project title //
Invicta House
Manchester
Moxy Hotel

drawing title //
Roof Louvre Enclosure

issue stage //		
CONSTRUCTION		
date //	drawn //	scale @ A3 //
Jan 21	AD	varies
project //	dwg number //	revision //
781	AA(27)103	B

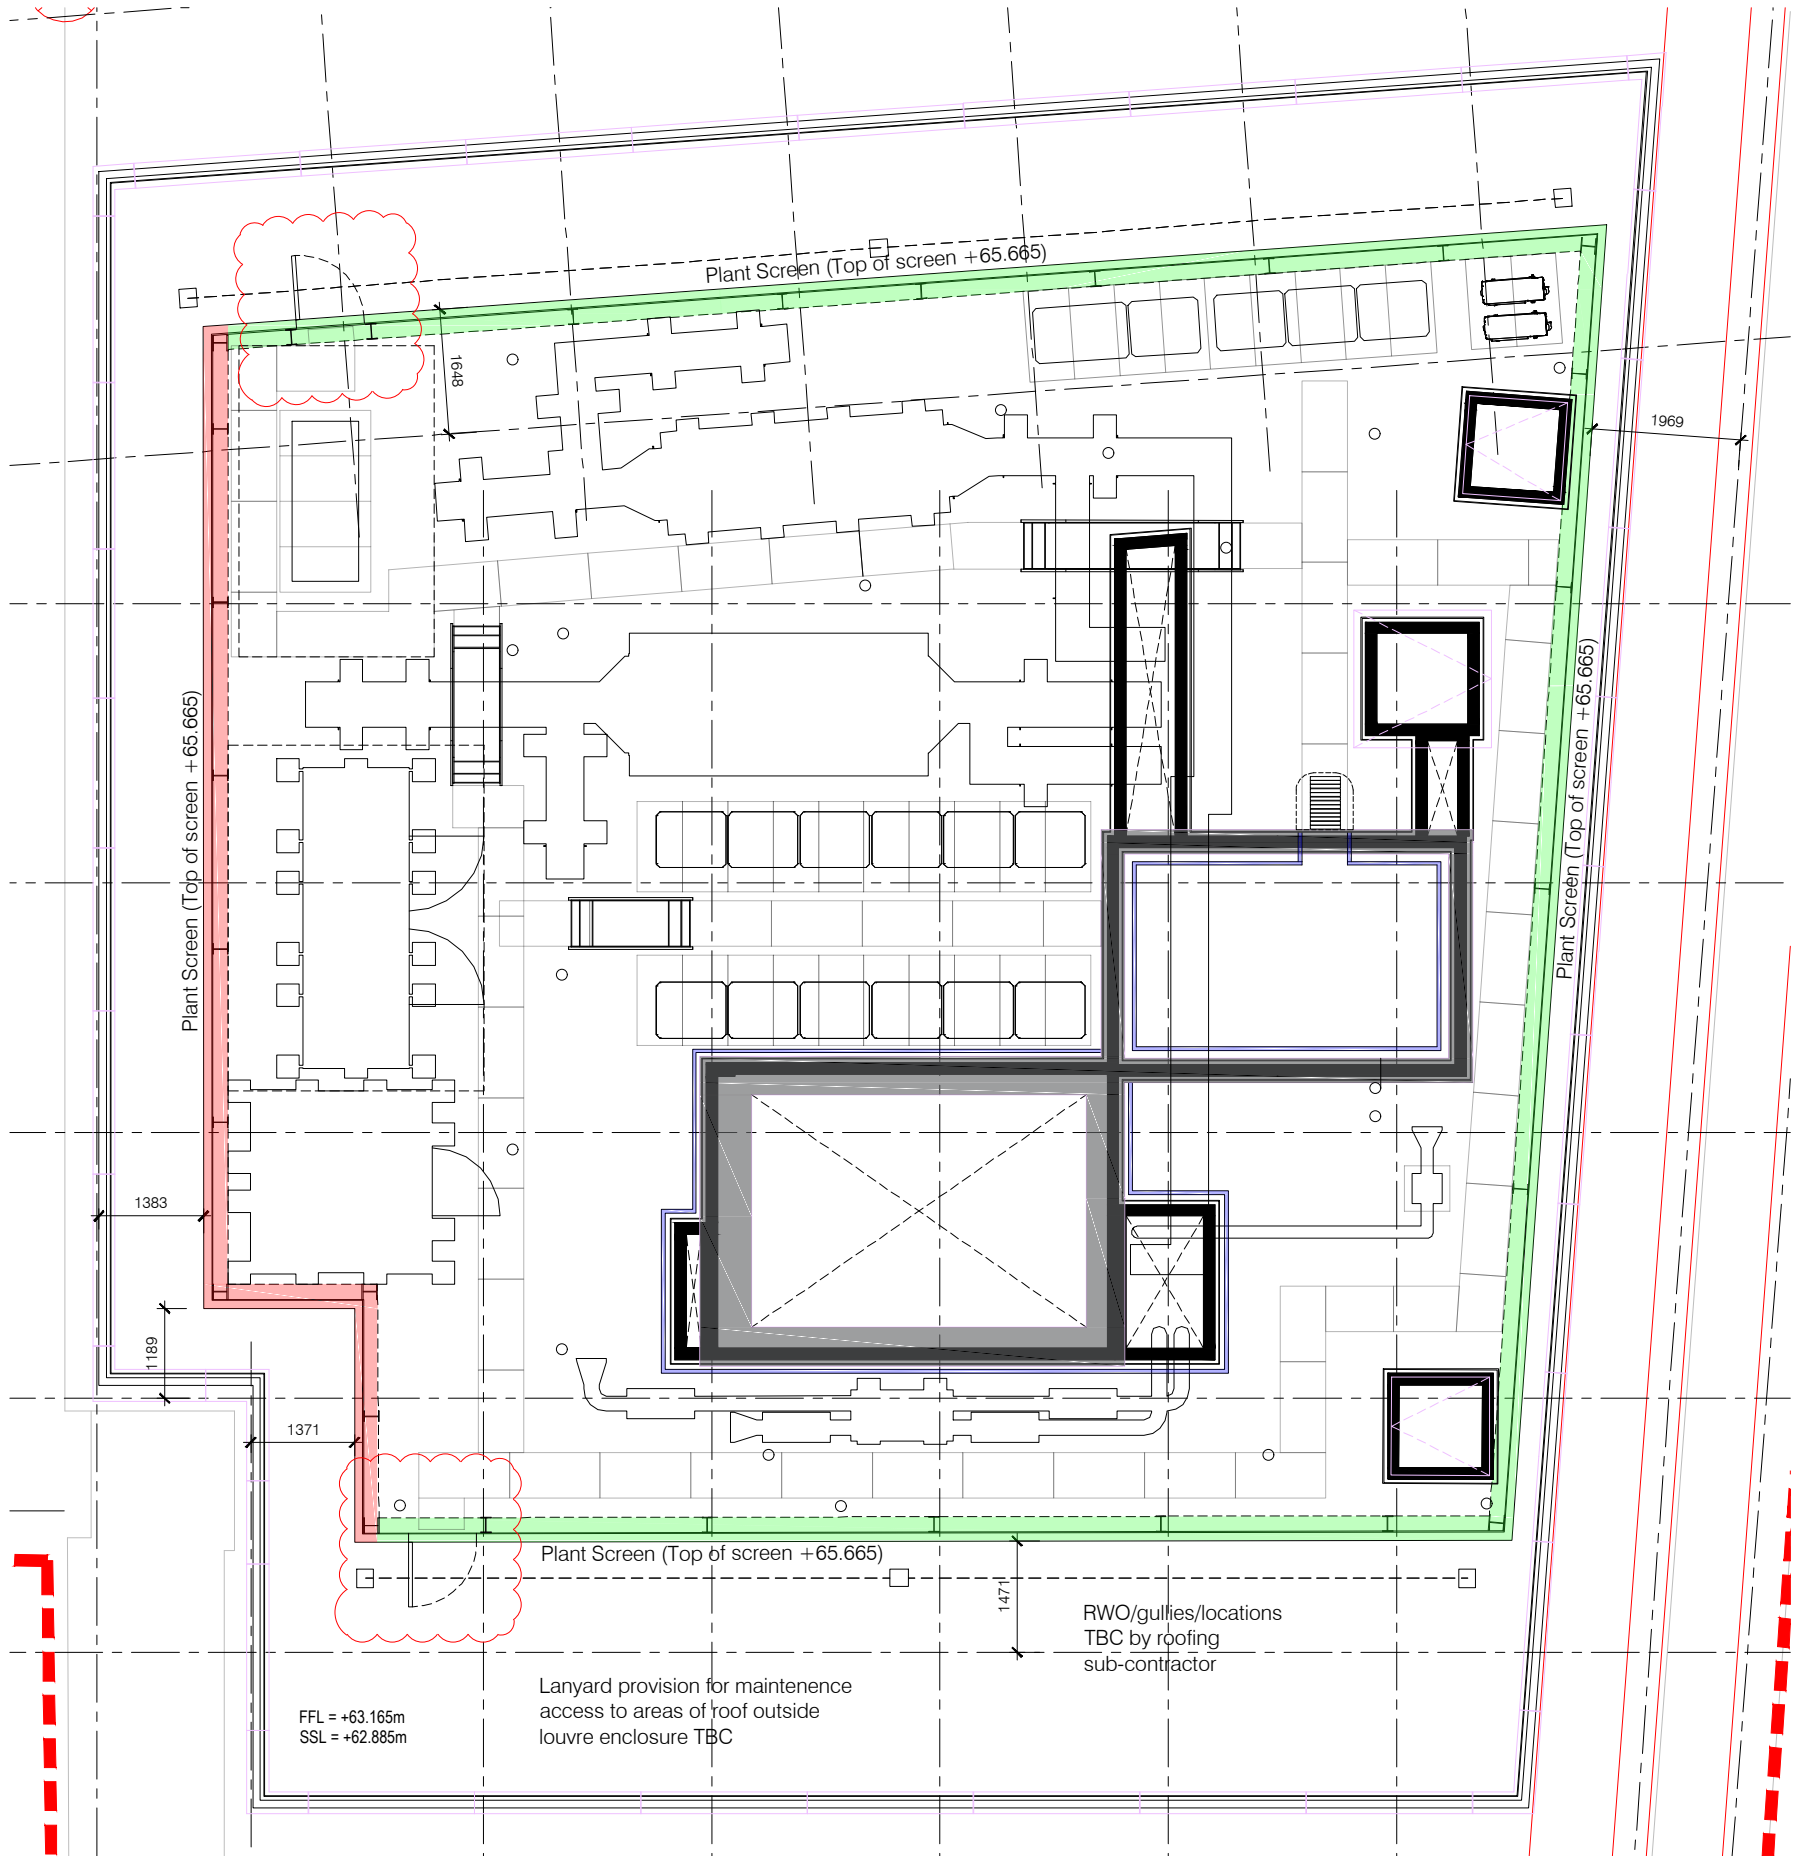
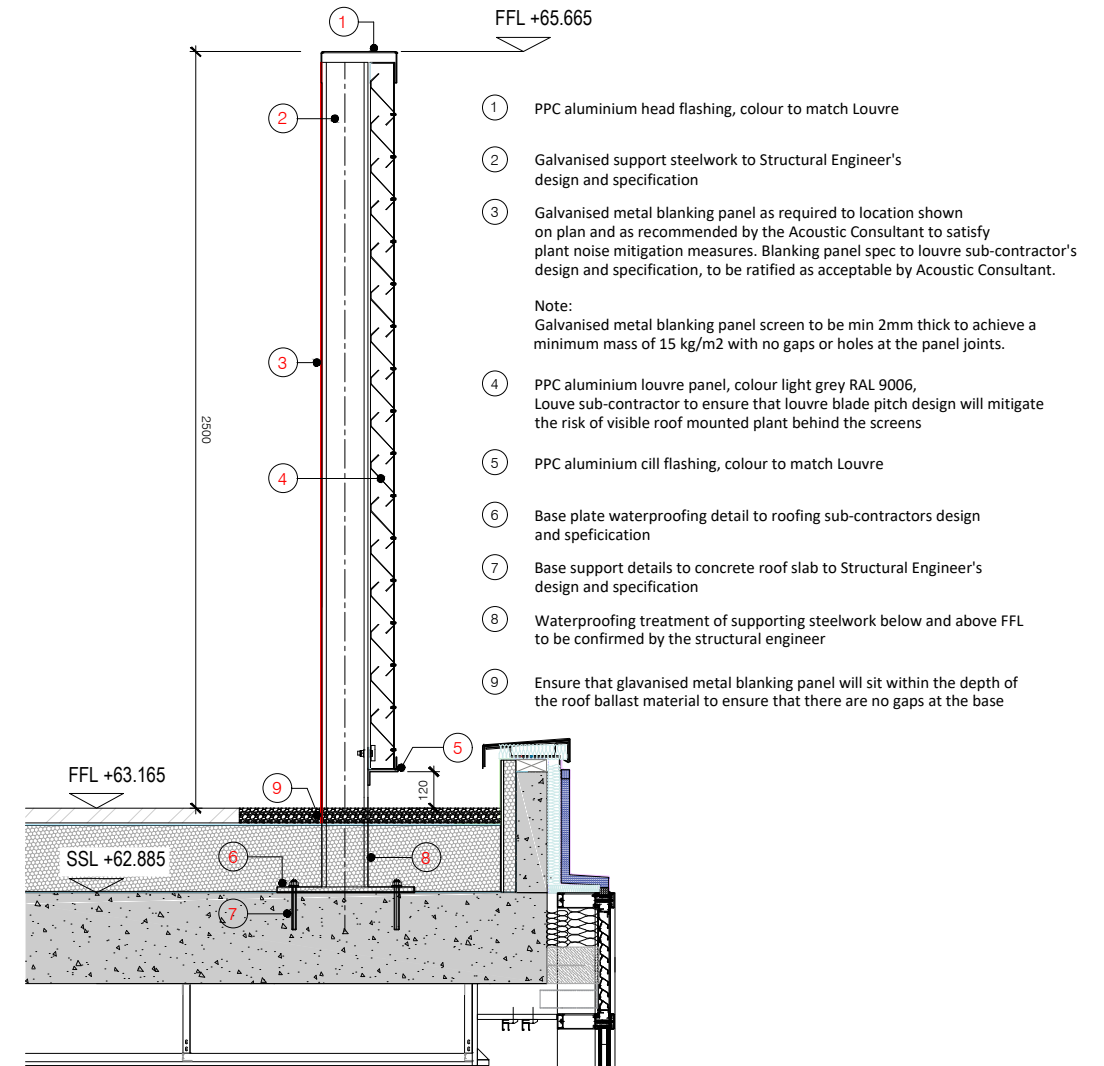
revisions //	by //	date //
A	AD	11.01.21
Height of louvre updated to suit M&E requirements; Extent of blanked louvre panel updated to show West side only as per acoustic consultant comments; note added confirming min thickness and mass of metal blanking panels required as per acoustic consultant comments; Blanking panels moved to opposite side of supporting steelwork to reflect acoustic consultant comments; note added to ensure that metal blanking panel sits within depth of roof ballast to ensure no gaps at the base condition.		
B	AD	19.01.21
Doors added to louvre screen; Updated M&E layout incorporated; Stepover locations update to suit MEP layout
